Planning, Land Use and Mobility Committee Report DIR 2020-882-DRB-SPP-MSP

Site Location: 4505 N. San Blas Avenue
Woodland Hills, CA 91364

Project: Application for Director's Determination of Project Permit Compliance for construction of a 3-story, 2,986 SF Single Family Residence in the Girard Tract and the outer core of the Mulholland Scenic Parkway Specific Plan.

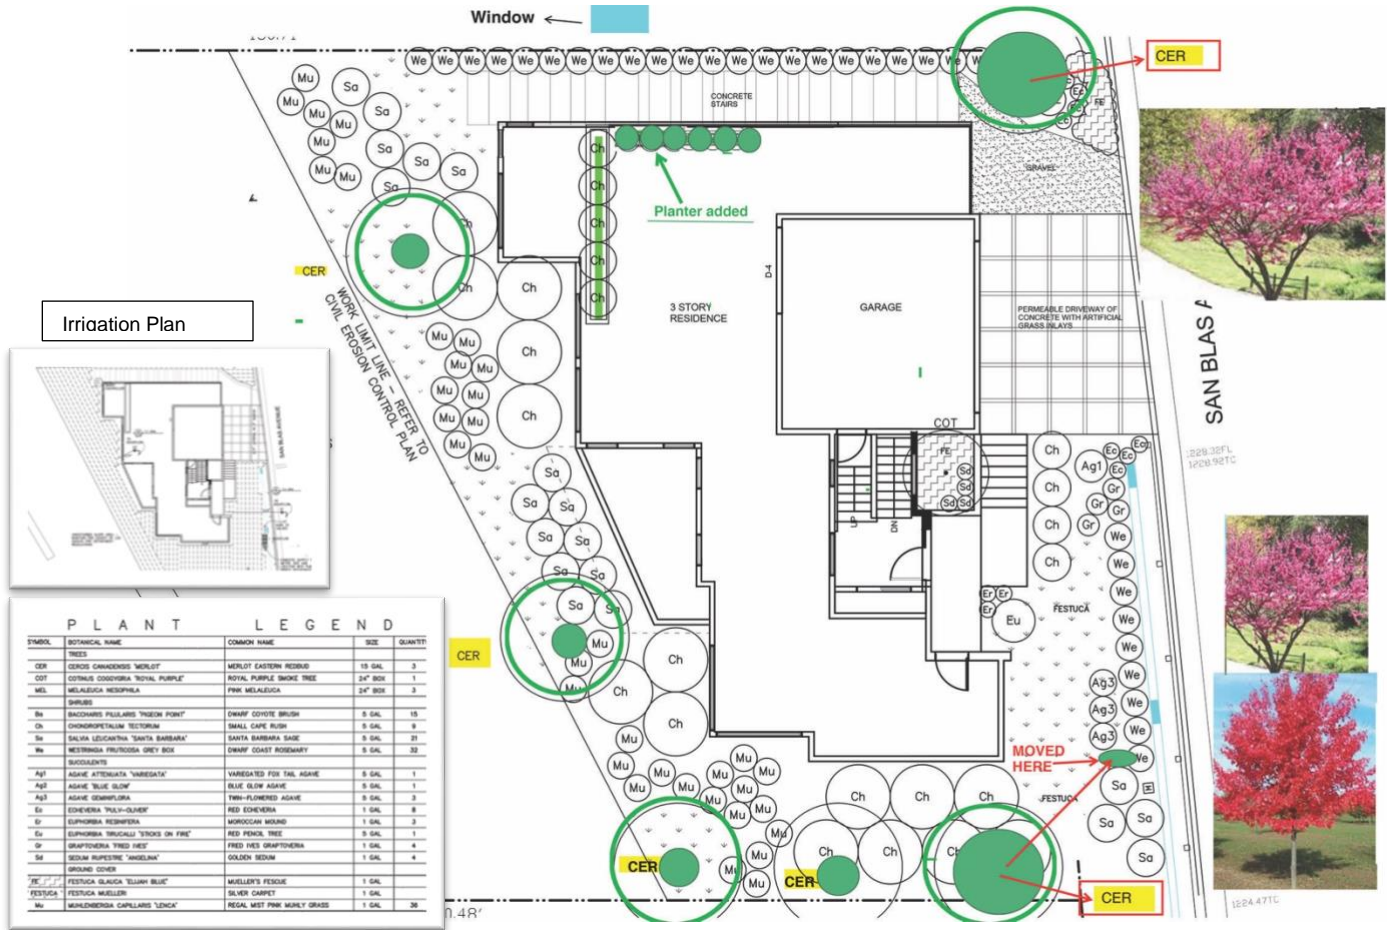
The illustration to the left indicates downspouts from roof barrels. Run-off and drainage from the building will be handled by downspouts and a French drain that direct rainfall into 530- and 850- gallon subsurface rain barrels anchored to a grade beam on the site. Overflow is directed to an existing diversion channel lower on the property. Permeable

hillside coverings and planting on the top portion of the property will allow for even hillside absorption without resulting in major water run-off onto neighboring properties

below. Rain barrels will be partially submerged into the ground, screened with plants on all sides.

Landscaping and Tree Survey

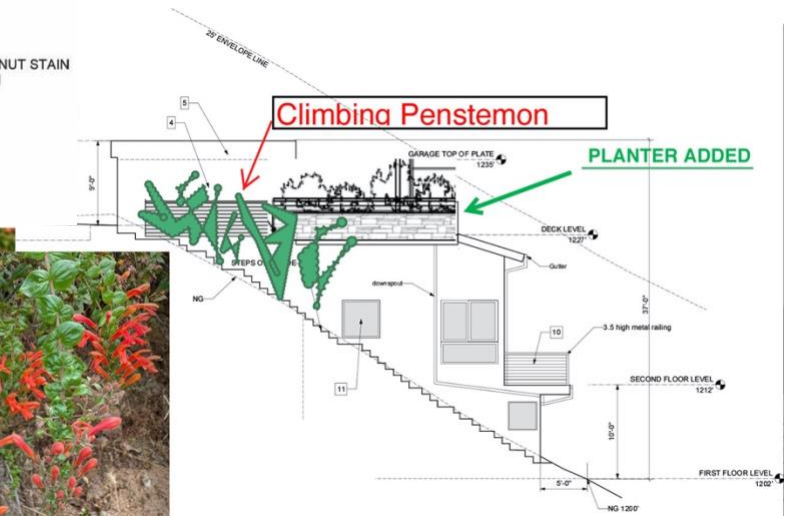
There are no protected trees on the property. The landscaping plan features 6 Merlot Eastern Redbud trees (Locations shown above), 1 Royal Purple Smoke tree, and 3 Pink Melaleuca trees, 25 succulents and approximately 77 shrubs plus multiple groundcover grasses. The only hardscape indicated is a front entry walkway to the garage/driveway and side yard steps. The driveway is permeable consisting of fake grass in between concrete panels. The rooftop side-pair of off-street parking is accessed via gravel surface.

At the recommendation of the PLUM Committee, Climbing Penstemon has been added to the project of the north façade to mitigate the large expanse of blank wall facing the adjacent neighbor along with additional planters next to the rooftop parking.

Structure cross-section through garage showing 25’ height envelop compliance.

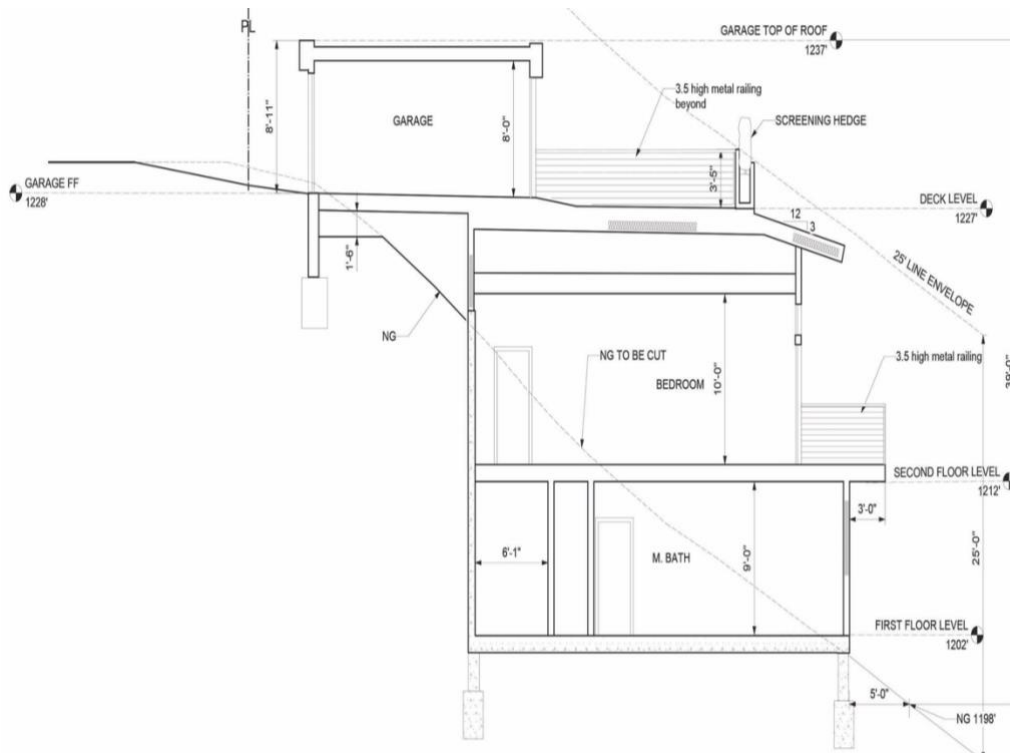
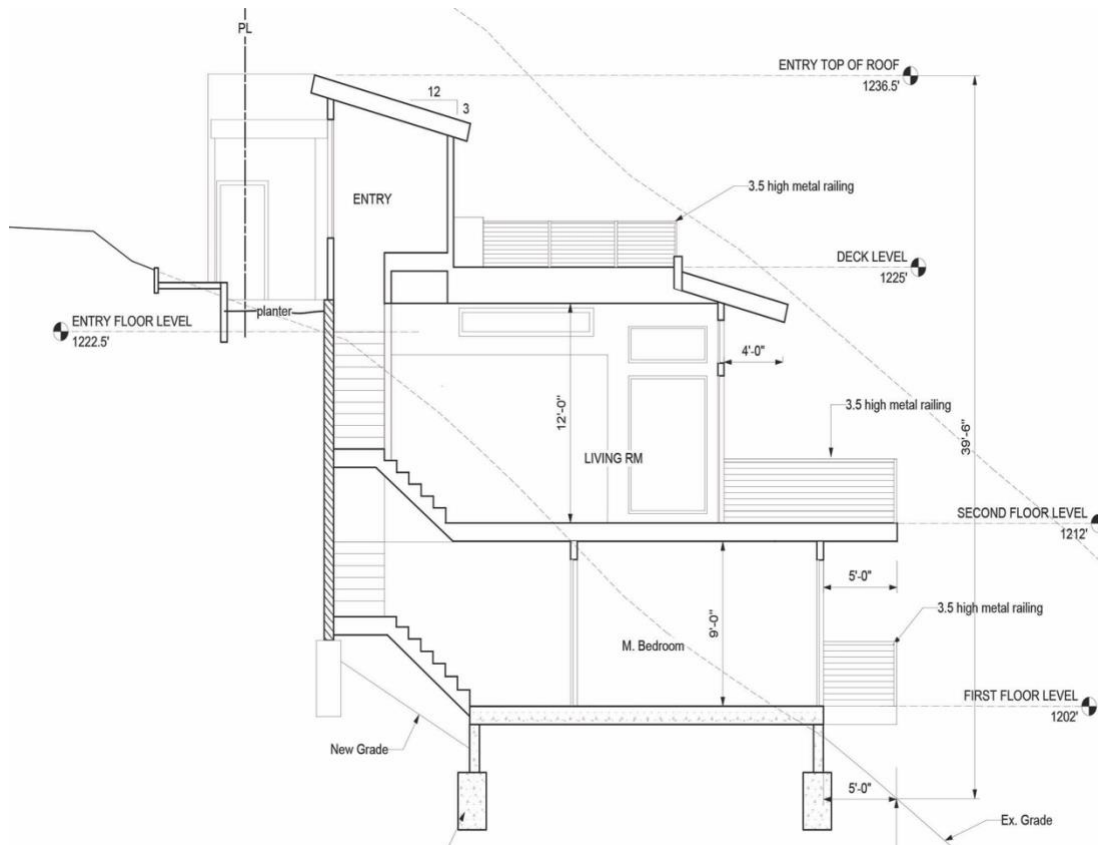
finished grade at the flat roof. Due to the top floor being primarily rooftop decks, structural elements stay under the 25' envelope above natural grade according

to the plans submitted. (see pgs 8 & 9)
